JABIRU AIRCRAFT PTY LTD

SERVICE BULLETIN: JSB 031-1

Date: 14th April 2011

Subject: Jabiru Engine Through-Bolts

Figure 2 – 12-Point Nuts

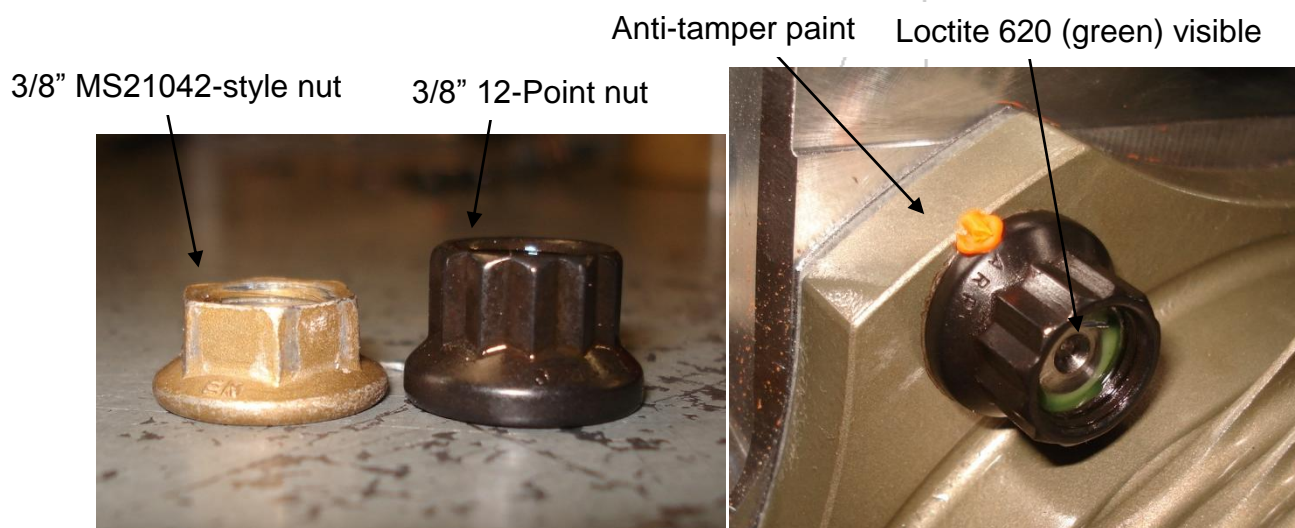
- Testing has shown that 12-point nuts (Figure 2) can carry a slightly higher load than the original MS21042 type nuts. As they are longer they also spread the tension load over a higher number of threads on the bolt. This reduces the load concentrated on any given thread and improves the ultimate strength and fatigue life of the assembly.

- If the 12-point nuts are used on the original through-bolts then they will overhang the studs as shown in Figure 2 (right) due to their extra length. Normal aircraft practice is to ensure that a minimum of around 1.5 threads project through the nut, however in this case that is not necessary. Figure 3 shows an illustration of 3 through-bolts fitted to an engine. It can be seen that the thread projects the required amount from the old MS21042-style nut but is recessed inside the 12-point nut. However, due to its extra length the 12-point nut is actually engaging with at least 1.5 – 2 threads more and produces a stronger connection. Also, during assembly with “short” through-bolts it is necessary to put one nut in position and then lock it there by screwing a 3/8” UNF bolt into the recess so that the nut on the other end of the stud can be tightened (with the MS21042 style nuts the same thing was achieved by screwing a second nut onto the protruding thread as a lock nut).

- The base of the 12-point nuts must still be lightly chamfered when used on older cylinder barrels to clear the radius at the base of the cylinder. Newer cylinders, like that shown in Figure 2 (right) are a different design and may not need chamfered nuts – but overhaulers must confirm this before final assembly.

- c) Mark the completed nuts with anti-tamper paint as shown in Figure 2 (right).
 - d) Repeat this process on all the remaining through-bolts and studs, working outwards from the middle cylinders as normal.

- Any engine which is being overhauled or having major maintenance carried out should be upgraded as follows:
 - a) The existing MS21042 style nuts must be replaced with 3/8" 12-point nuts.
